STAFF REPORT
COMMUNITY DEVELOPMENT DEPARTMENT

HEARING DATE: 7/26/2022
 TO: Mayor & City Council
 FROM: Joe Dodson, Associate Planner
 208-884-5533
 SUBJECT: H-2022-0001
 Pinedale Subdivision

Annexation and Zoning of 1.22 acres of land with a request for the R-8 zoning district and a Preliminary Plat for 7 building lots and 1 common lot on 1.22 acres in the requested R-15 zoning district, by Pine Project, LLC.

B. Preliminary Plat (dated: May 2022)

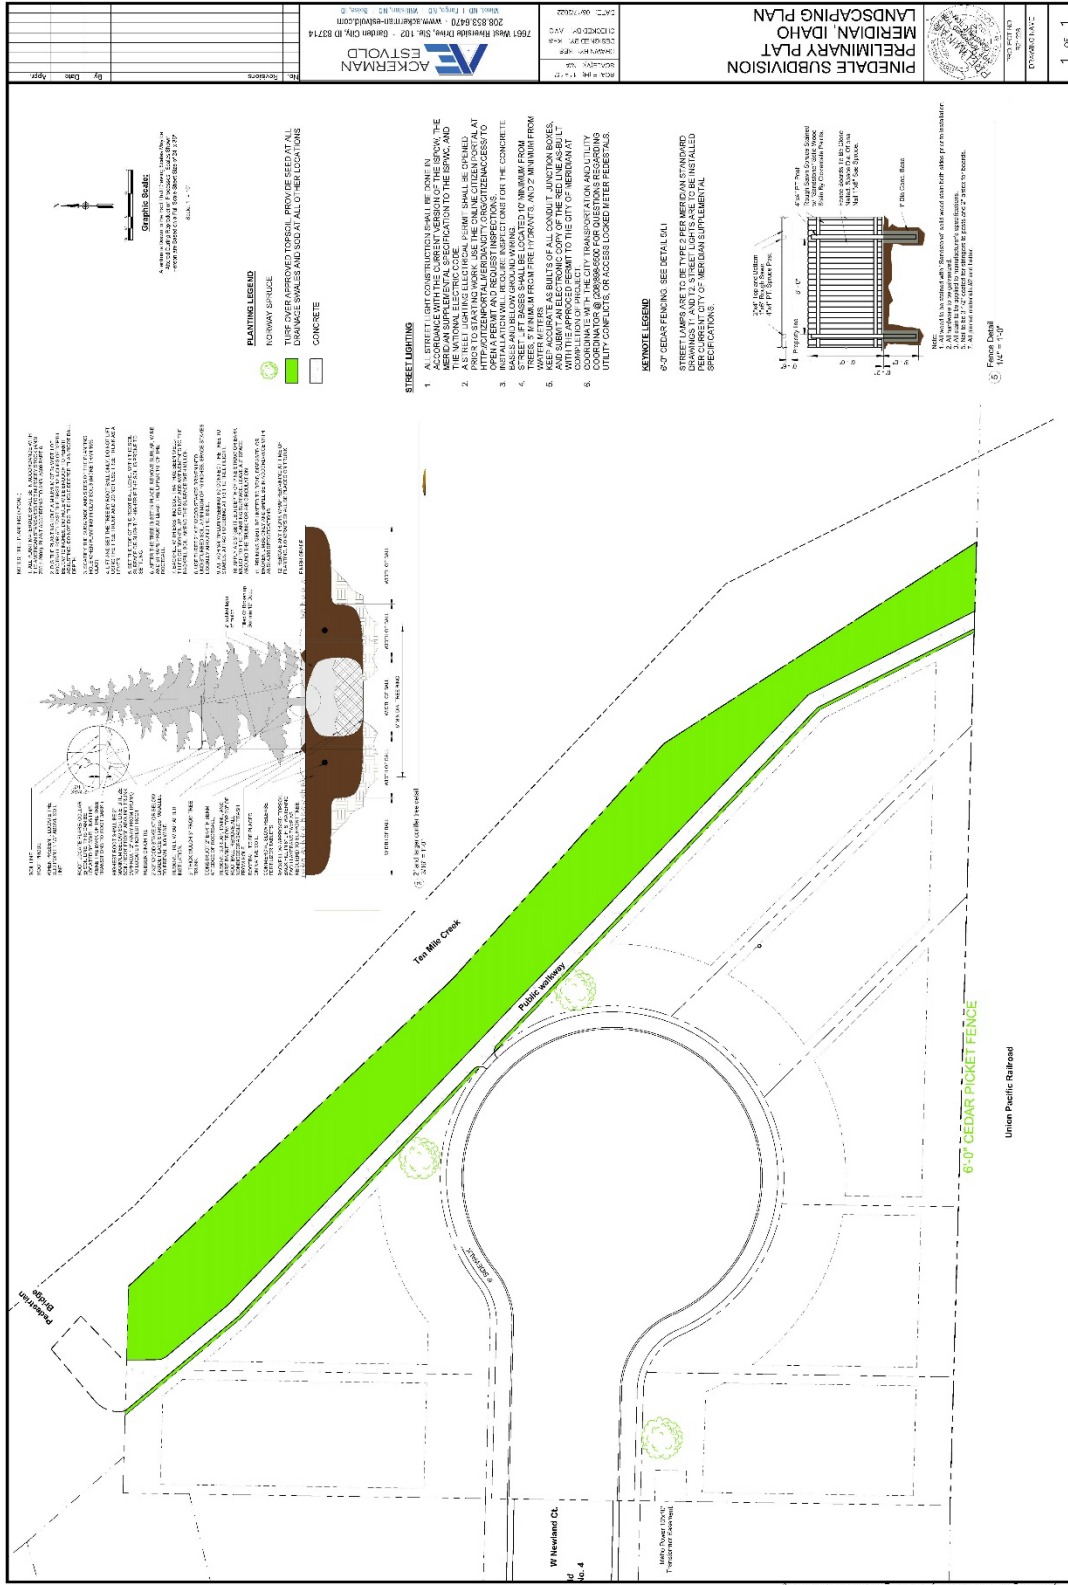
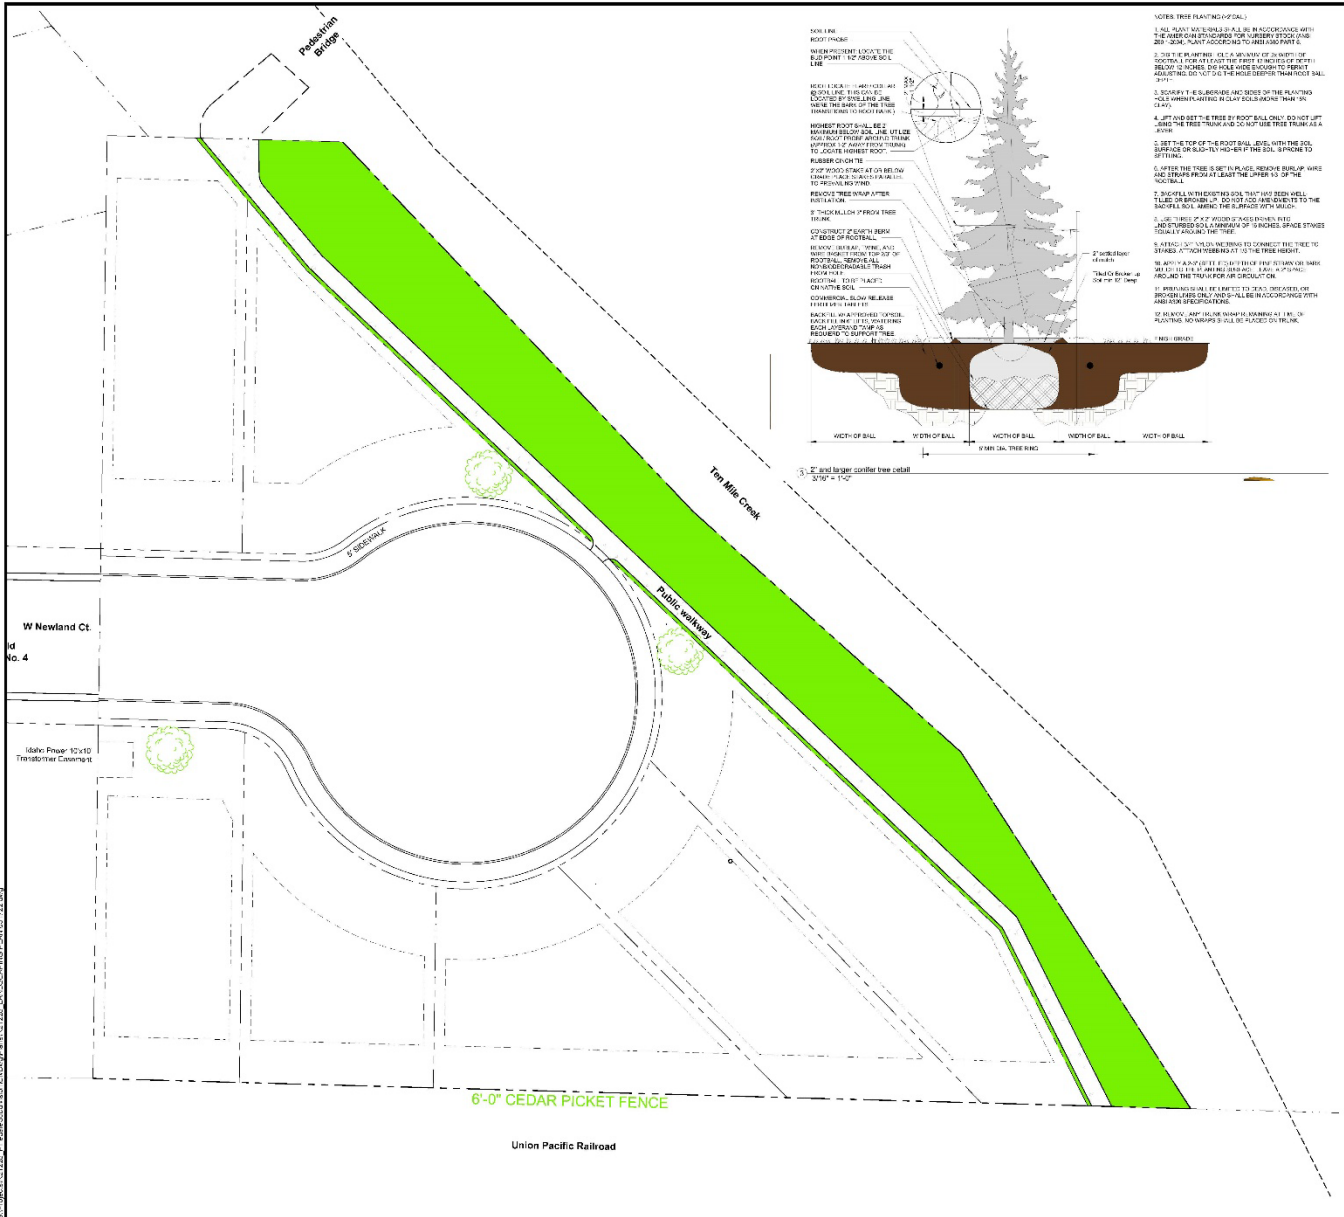
The proposed use is detached single-family residential with an average lot size of 4,399 square feet and a minimum lot size of 4,029 square feet, based on the latest submitted plat (Exhibit VII.B). This use is a permitted use in the requested R-8 zoning district per UDC Table 11-2A-2 and all lots meet the minimum lot size requirement of 4,000 square feet. The Applicant has not noted if this is a phased project, however Staff anticipates it to develop as one phase due to the size of the proposed project.

The residential lots appear to meet all UDC dimensional standards per the submitted plat. In addition, all subdivisions are also required to comply with Subdivision Design and Improvement Standards (UDC 11-6C-3). *The proposed preliminary plat and submitted plans appear to meet all UDC requirements including lot frontage and lot size. Further, the Applicant has depicted the building envelope on each lot on the plat for the purpose of showing future building footprints. As noted, the Applicant is anticipating constructing smaller homes than seen in recent years and smaller than those within Chesterfield. In addition, the setback lines on Lot 2 do not depict how code handles setbacks within a triangle so this building lot will have a slightly smaller building envelope than shown.*

Access is proposed via extension of W. Newland Street (an existing residential local street) into the site and is proposed to terminate within the site as a full cul-de-sac. ACHD has previously approved the proposed access with the additional condition that the radius be widened to 50 feet instead of 48 feet as currently shown. This may reduce the lot size of Lot 6 below the minimum 4,000 square foot size. Staff finds that if this is the case, there is room to modify the lot lines to ensure continued compliance with the requested R-8 zoning district.

A 5-foot wide attached sidewalk is proposed along the Newland Street cul-de-sac, consistent with UDC and ACHD requirements. In addition, the Applicant is proposing a 5-foot wide micro-path along the east boundary that connects to the cul-de-sac for the purpose of providing a connection to the future multi-use pathway approved with Foxcroft Subdivision on the east side of the adjacent Tenmile Creek. The proposed sidewalks meet UDC 11-3A-17 and ACHD standards and the micro-path lot meets UDC 11-3A-8 standards.

2. The preliminary plat included in Section VII.B, dated May 2022, is approved as submitted.
 3. The landscape plan included in Section VII.C, dated May 11, 2022, shall be revised as follows prior to submitting for Final Plat approval:
